PLANNING BOARD MEETING AGENDA

To: Town of Berwick , Planning Board
From: Lee Jay Feldman, Director of Planning
Date: 8/12/2019
Re: 71 Sullivan Street- Community Parking Lot

COMMUNITY PARKING LOT 71 SULLIVAN STREET BERWICK, MAINE

SITE PLAN
COMMUNITY PARKING LOT
71 SULLIVAN ST
BERWICK, ME 03901

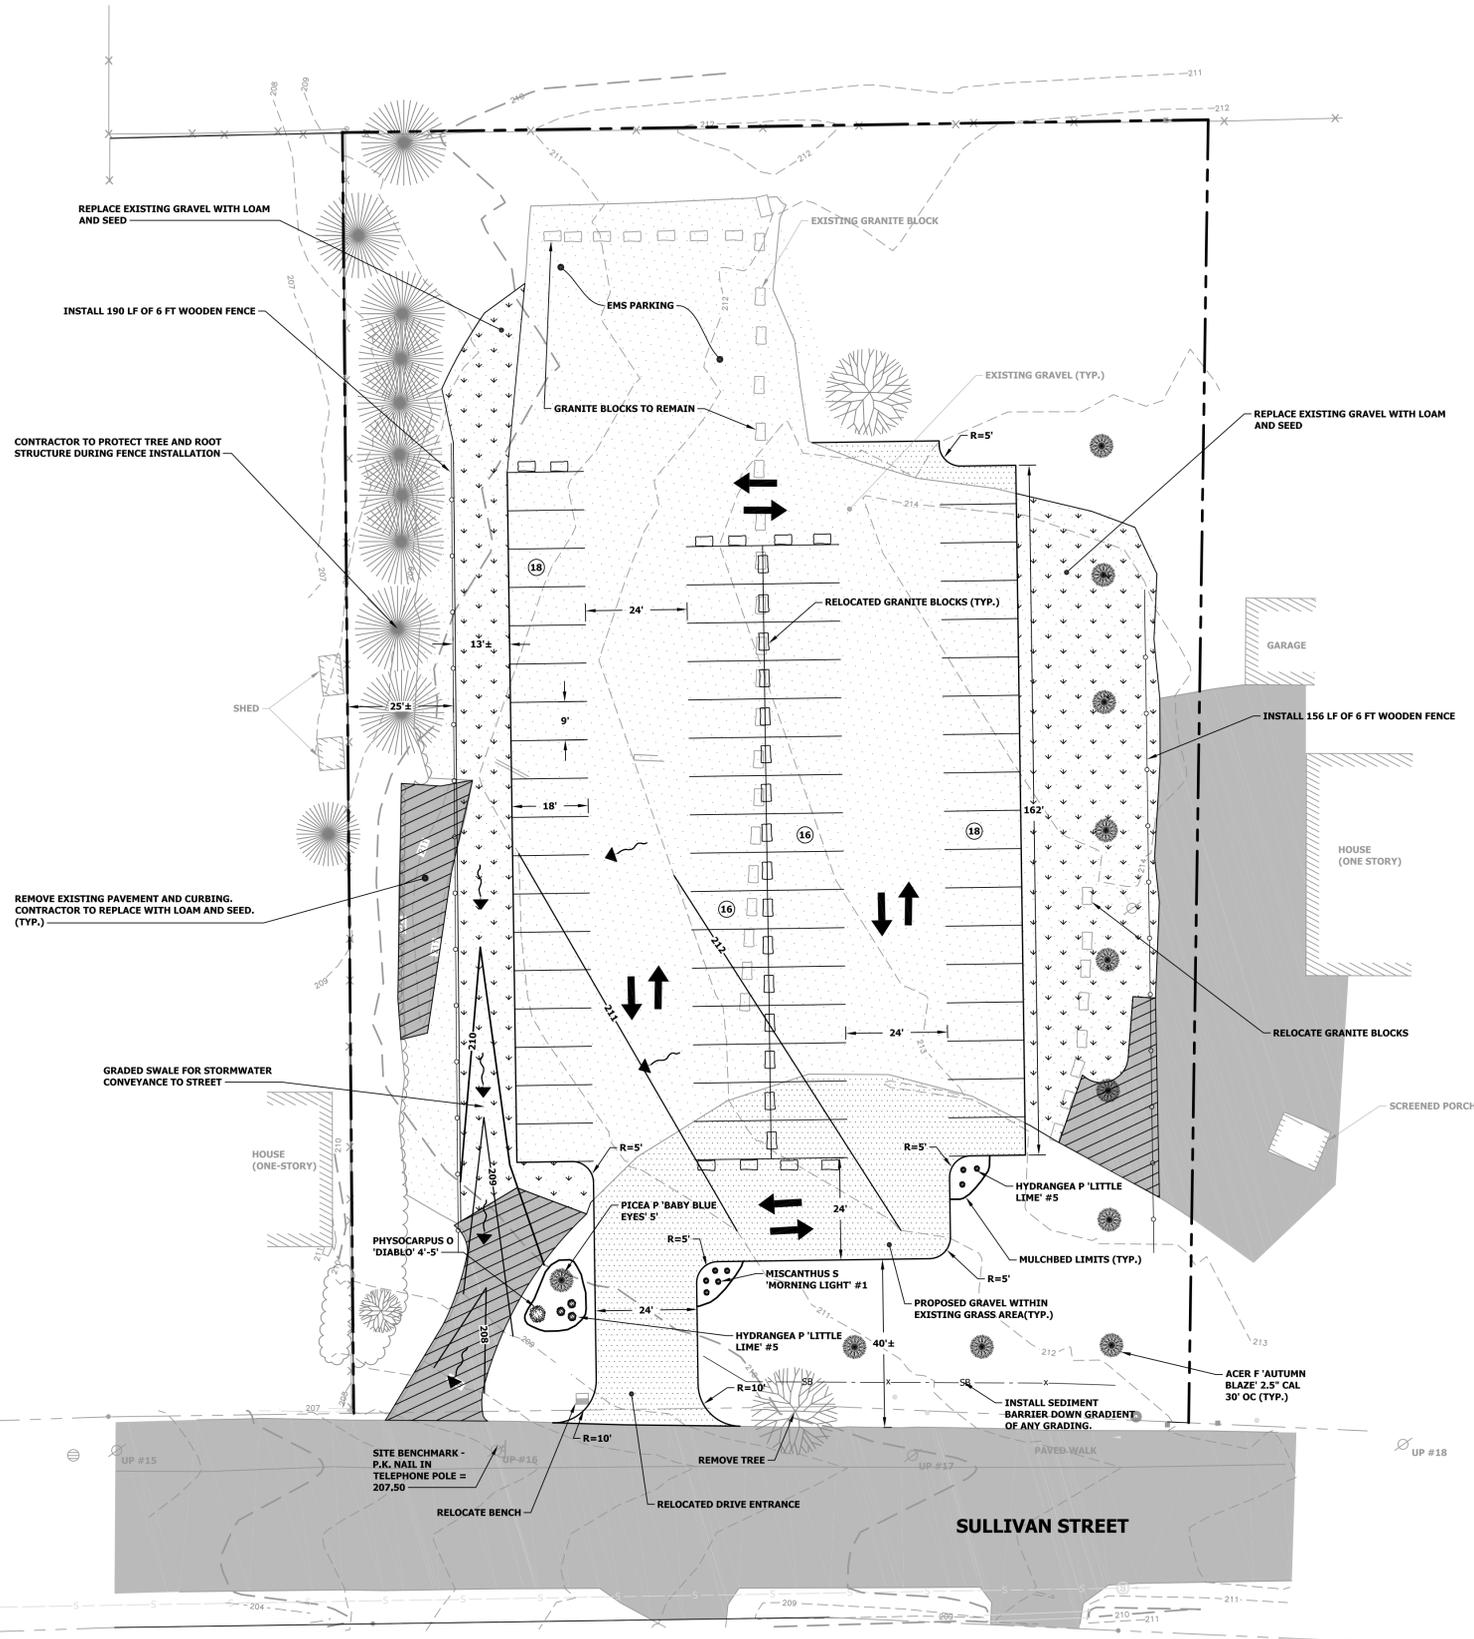
The applicant has submitted a survey plan which has not been stamped by the surveyor however the assumption could be made by the REFERENCE statement on the plan that this information is accurate at this time.

Based on this information, it seems that the applicant is improving the situation on the site by pulling back the proposed parking area of 68 spaces to include a substantial distance from the property lines. By pulling the parking back they are able to provide screening, with 6' high fencing along both neighbors properties and adequate drainage along both side property lines.

The site currently contains a number of large granite blocks which will be relocated on the site to assist in demarcation of the parking spaces in the middle of the site.

A great deal of pavement and gravel will be replaced with loam and seed which will assist with the drainage as well a visual improvement to the site.

The driveway opening is being relocated to the north by approximately 50 feet center line to centerline and be widened to 24' which will provide a much safer point of ingress and egress.
